Docket Item # 4
BAR CASE # 2008-0233

BAR Meeting
December 17, 2008

ISSUE: Alterations
APPLICANT: The Pyne Company by Michael Molinari
LOCATION: 411 King Street
ZONE: CD/Commercial

Figure 3. Proposed alterations at 421 King Street.

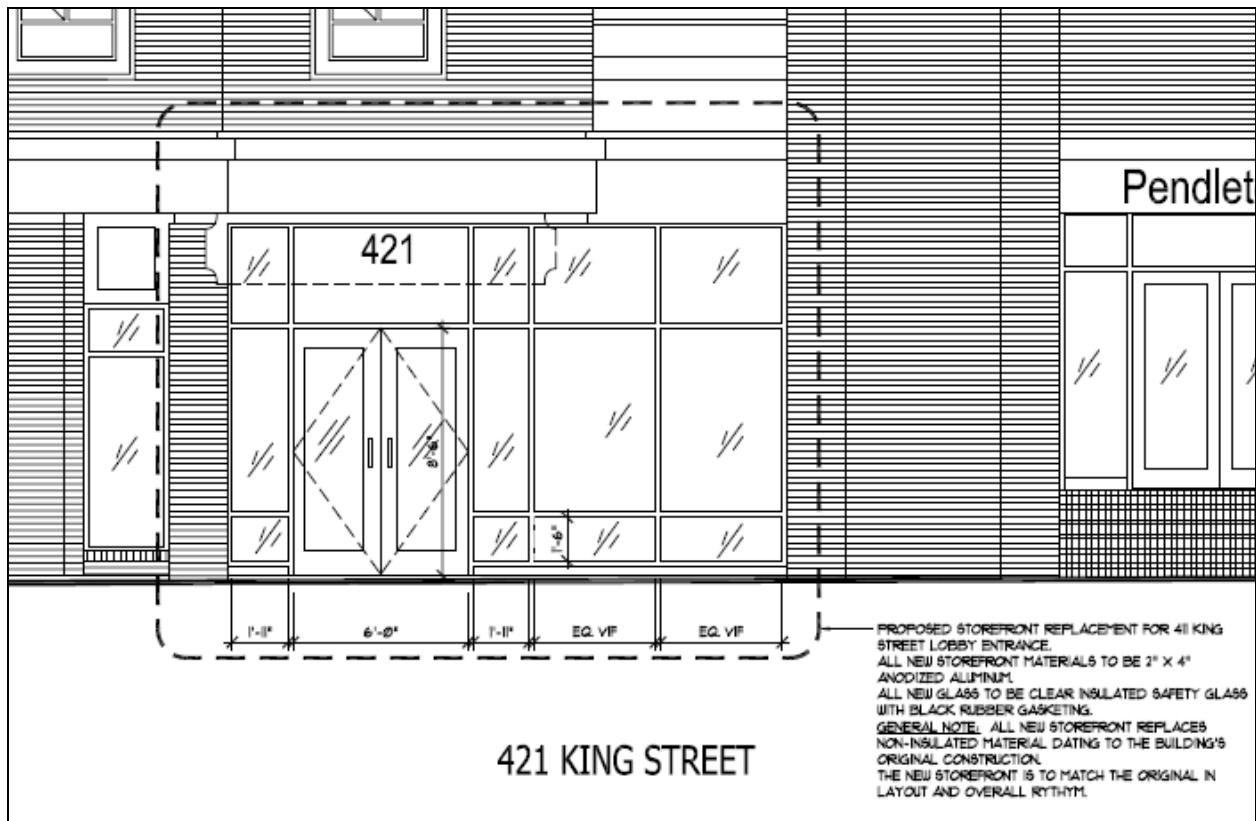
The existing storefront system will be removed and replaced with a new aluminum and glass storefront system for the 421 King Street lobby entrance. The storefront materials will be 2" x 4" anodized aluminum, with clear insulated safety glass with black rubber gasketing. The proposed entrance lobby will have a slightly different light configuration from the existing entrance.

As this building is not considered historic, there is no concern for the loss of historic fabric. The proposed alterations will introduce a slightly different light configuration for the windows for the three entrance lobbies but will not affect the defining features of these spaces. While staff has

Staff has no objection to the proposed alterations and recommends approval of the application as submitted.

Figure 5. Proposed alterations at 123 North Pitt Street.

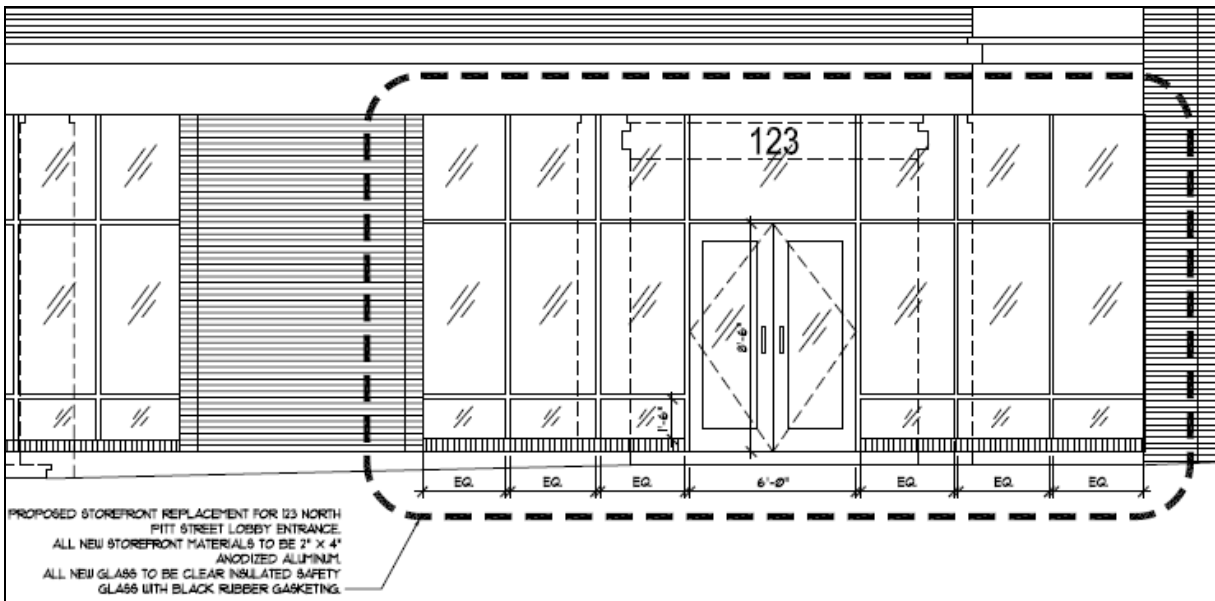
The existing storefront system will be removed and replaced with a new aluminum and glass storefront system for the 123 North Pitt Street lobby entrance. The storefront materials will be 2" x 4" anodized aluminum, with clear insulated safety glass with black rubber gasketing. The proposed entrance lobby will have a slightly different light configuration from the existing entrance.

Figure 6. Proposed alterations at 130/132 North Royal Street.

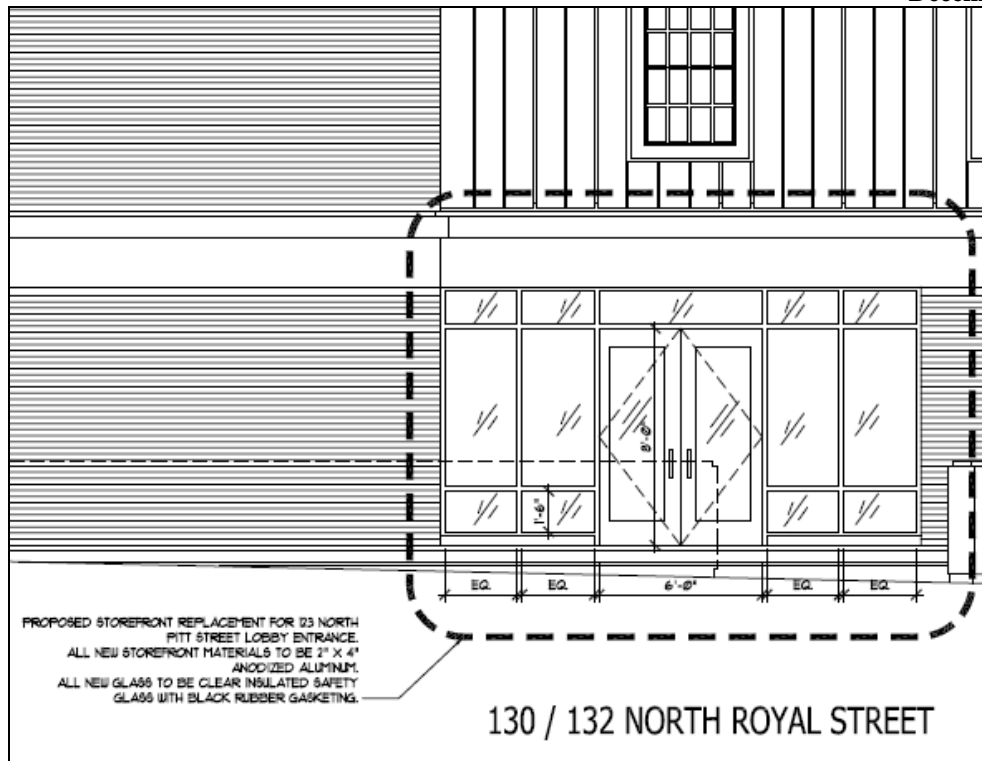
The existing storefront will be replaced with a new storefront, with materials to be 2"x4" anodized aluminum and clear insulated safety glass with black rubber gasketing. The proposed entrance lobby will have a slightly different light configuration from the existing entrance.
